SHEET		1		OF		1	
MESA TOPS AT RIDGEGATE		ENTRANCE ROAD ALT A — W/O WALLS					
JOB NO.		15950.12

MESA TOPS AT RIDGEGATE
ENTRANCE ROAD ALT B
WI WALLS

PRELIMINARY ROAD REDESIGN
ALTERNATIVE 1
MESA TOPS – CABELA DRIVE
1595018
10/28/2024
SHEET 1 OF 2

SHEET		MESA TOPS AT RIDGEGATE		H-SCALE	1"=150'	REVISION	BY	DATE
1		ENTRANCE ROAD ALT E		V-SCALE	1"=15'			
OF				DATE	10/31/23			
1				DESIGNED BY	JP			
				DRAWN BY	JP			
				CHECKED BY

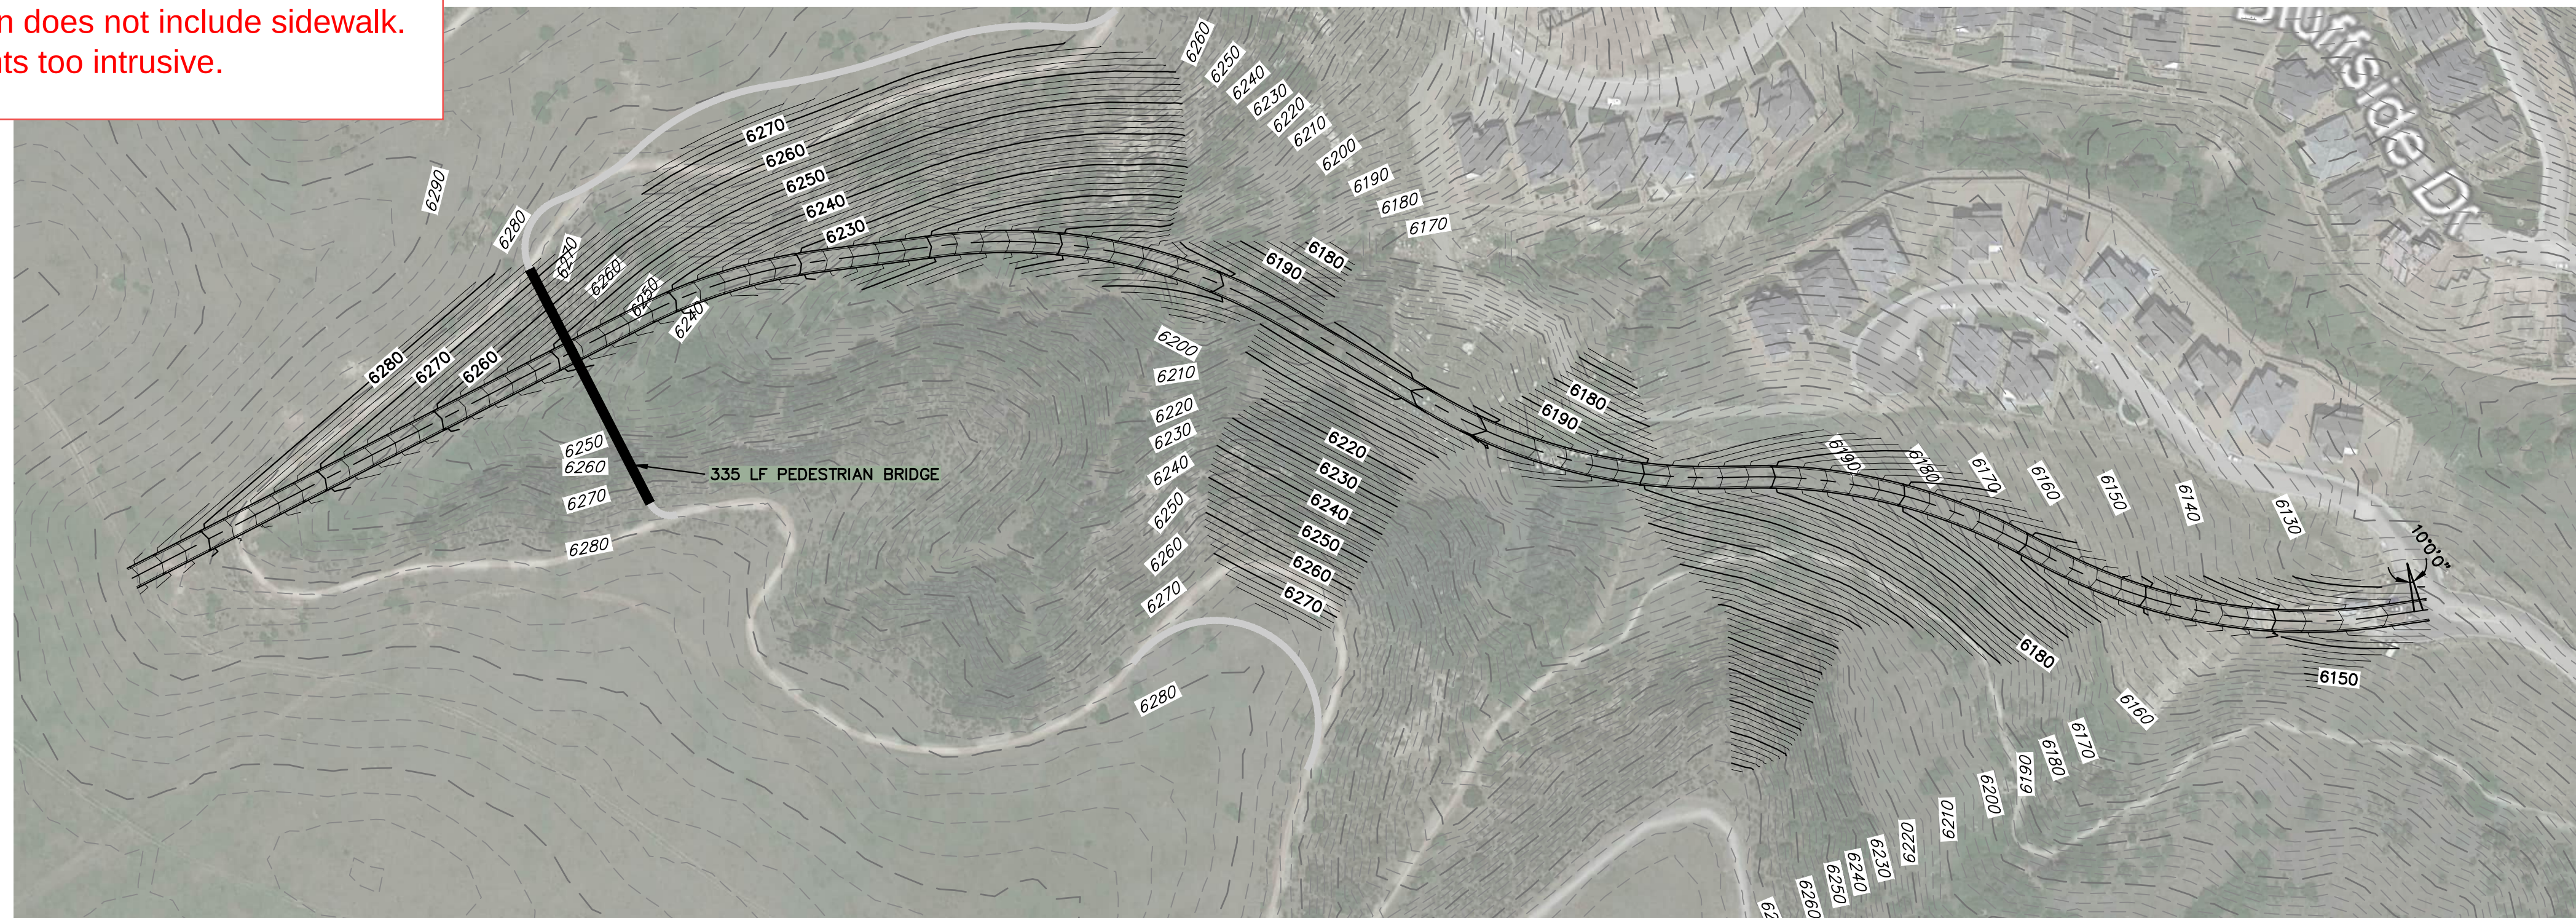
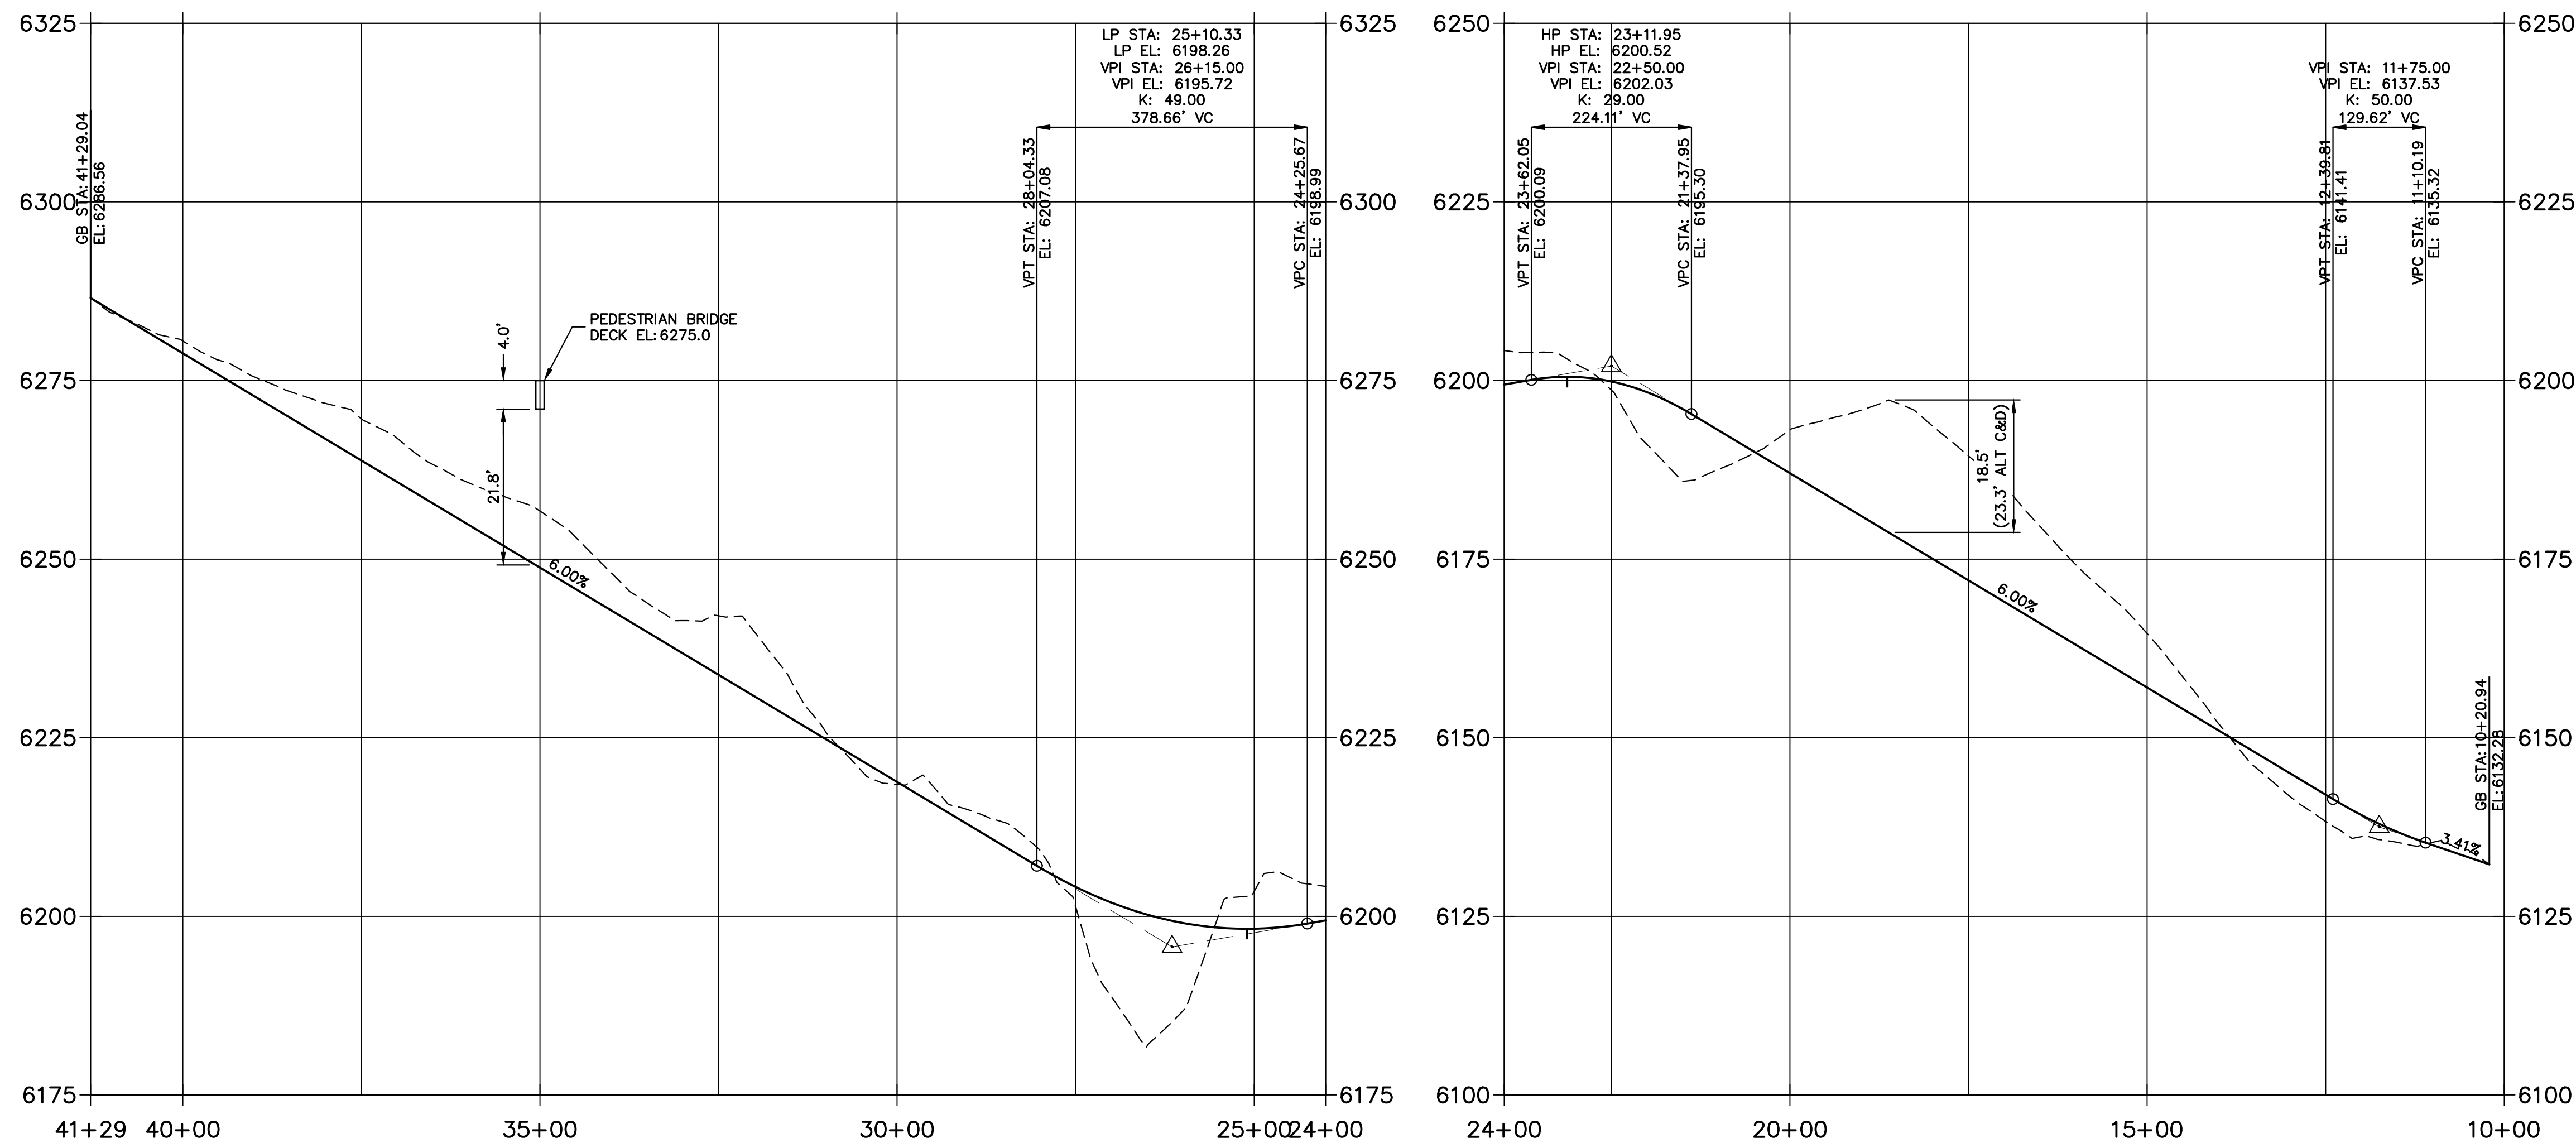
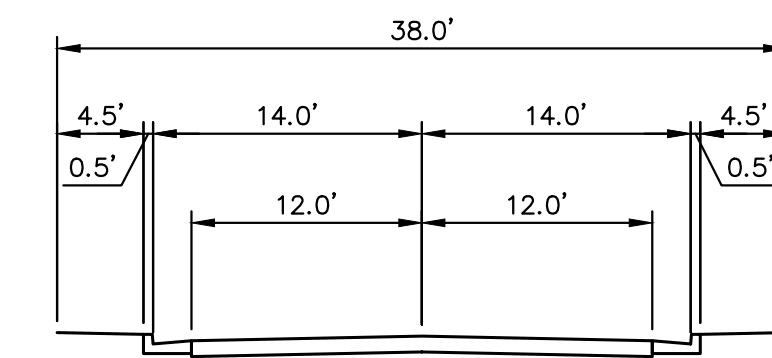
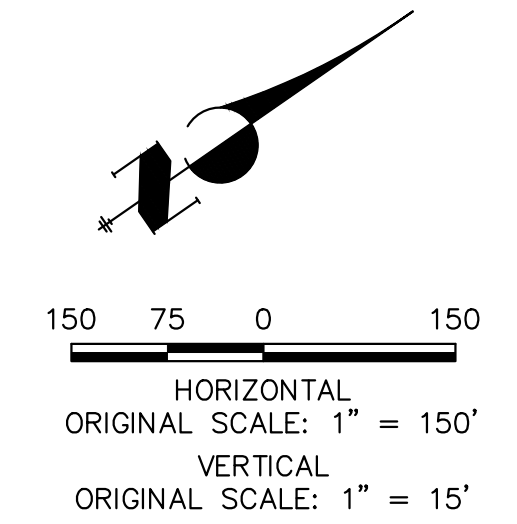
Option not selected -

- Grading extents cross the Retreat at Ridgeway boundary.
- Typical section does not include sidewalk.
- Grading extents too intrusive.

- Grading extents cross the Retreat at Ridgeway boundary.
- Typical section does not include sidewalk.
- Grading extents too intrusive.
